**Section 16 Planning Application for  
Proposed Religious Institution (the Supreme Kwan Ti Temple)  
with Ancillary Facilities and Associated Excavation and Filling of Land,  
Lots 1475 (Part), 1591 (Part), 1594 (Part), 1595 (Part), 1600 S.A (Part),  
1600 S.B (Part), 1602 (Part), 1622, 1624, 1629, 1630 S.A (Part), 1630 S.B,  
1630 S.C, 1630 S.D, 1631, 1632, 1633, 1634, 1635, and 1636 (Part) in D.D. 117  
and Adjoining Government Land, Tai Tong, Yuen Long**

**FURTHER INFORMATION (I)**

### **Responses to Departmental Comments**

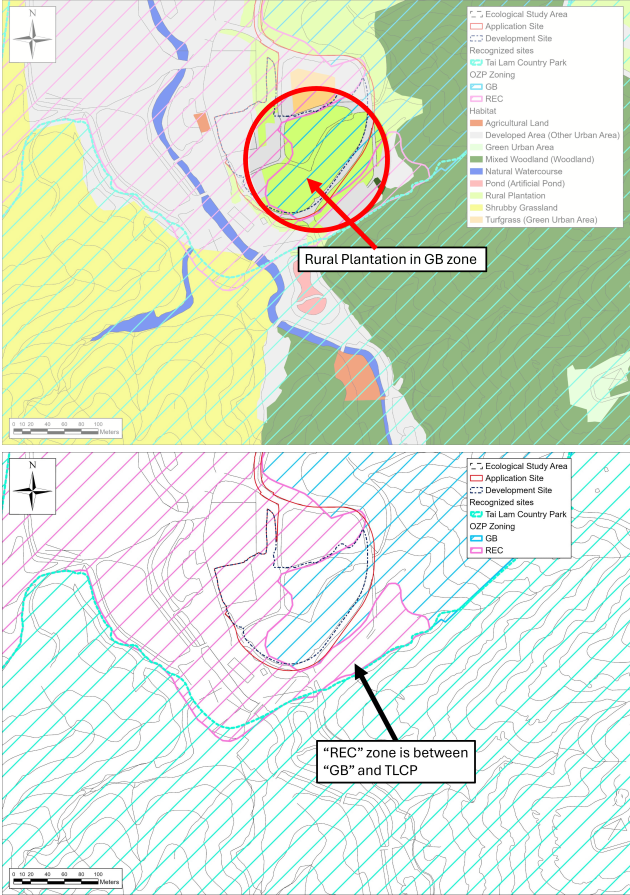
UD(12)	<p>13. <b>Photomontages (General)</b> – It seems that some of the photomontages may involve distortion and wide angle (i.e. panoramic view). Despite this observation, the comments in Paras. 4, 6 to 12 above remain generally applicable.</p>	<p>The panoramic view provides greater context, however the central portion of the photomontage is an accurate portrayal (without distortion) of the proposed development within its setting and, as noted, provides a sound basis for the assessment.</p>
UD(13)	<p>[1] As per our previous internal comments on the VIA to your office during pre-submission stage as well as our discussions over the phone on 13.5.2024 and earlier today, it is noted that your office have no particular comments on the selection of VPs including designating VPs at/near to Tai Tong Organic EcoPark and Tai Tong Lychee Valley as the public VPs seems not within unauthorised developments (subject to CID's checking/confirmation)</p>	<p>Noted.</p>

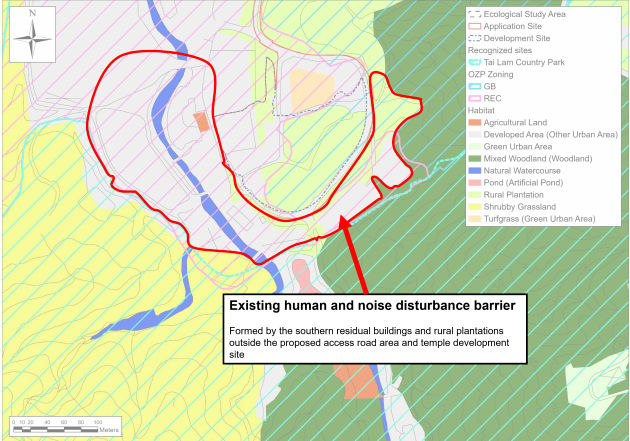
Item	Departmental Comments	The Applicant's Responses
LT(1)	According to the aerial photo of 2023, the Site is situated in area of rural fringe landscape predominated by temporary structures, open storage yard, farmland, woodland and scattered tree groups. From the site photos taken by DPO on 13.12.2024, the southern portion of the Site was covered with temporary structures, scattered trees groups and vegetation, while the northern portion of the Site was paved as an access road.	Noted
LT(2)	According to the planning statement, the application site comprises 3 portions, the Development Area (the Temple site), the Tai Tong Kwan Ti Square Area, and Access Road. In Table 4.4 (Summary of Tree Recommendations) and Section 4.4, a total <b>596</b> existing trees within the application site boundary (including 474 trees in Development Area, 61 trees in Tai Tong Kwan Ti Square Area and 61 trees in Access Road) were identified, of which <b>62</b> trees are proposed to be retained, <b>seven</b> trees are proposed to be transplanted, <b>527</b> trees including 10 trees of undesirable species (i.e. <i>Leucaena leucocephala</i> ) are proposed to be removed. For the proposed new trees planting, a total <b>620</b> new trees (i.e. 507 nos. of trees and 113 nos. of whips) would be accommodated at the proposed temple landscape (the Development Area), access road verges and within the existing Tai Tong Kwan Ti Square. The proposed planting species was listed in Table 10.1 of Appendix VI (Landscape Proposal Report).	Noted.
